As part of our continuous improvement program, we have scheduled a changing on the following items:

OLD PART NUMBER	DE00700 – DE00701
NEW PART NUMBER	DE00710 – DE00711 – DE00712
AVAILABLE FROM DELIVERIES	February / 2021

DE71

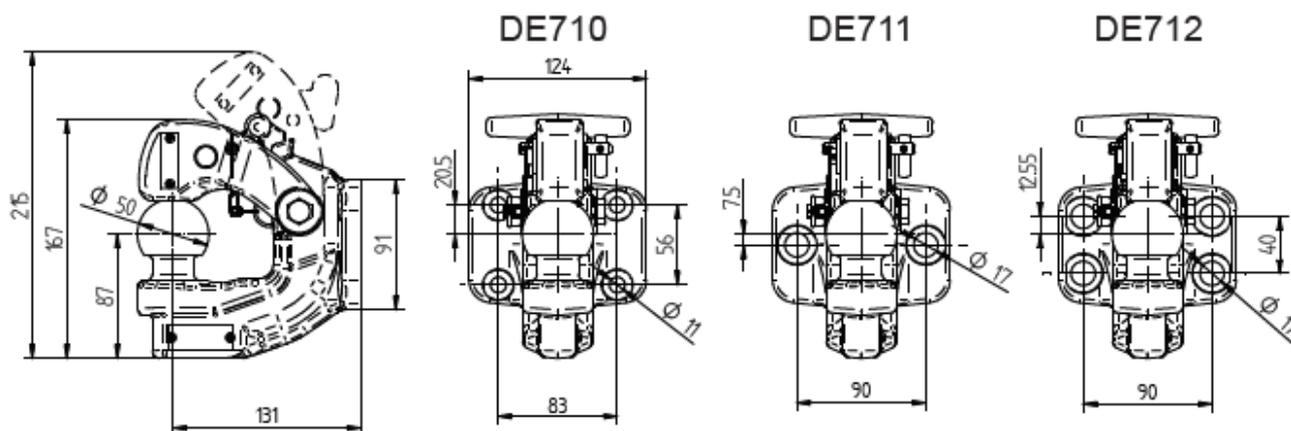
Mixed pin+ball coupling DE71, homologated according to the ECE R55 (Class S), has a D-Value of 28kn, in line with our Iveco Daily towbars.

Codice Part number	Flangia Hole pattern [mm]	Valore D D-Value [kN]	Valore Dc Dc-Value [kN]	Massa S S-Load [kg]	Peso Weight [kg]	Omologazione Homologation		
						Classe Class	ECE R55	Tipo Type
DE00710	83x56	28	28	330	5,5	S	E3 01-3014	DE710
DE00711	90	28	28	330	5,5	S	E3 01-3015	DE711
DE00712	90x40	28	28	330	5,5	S	E3 01-3042	DE712
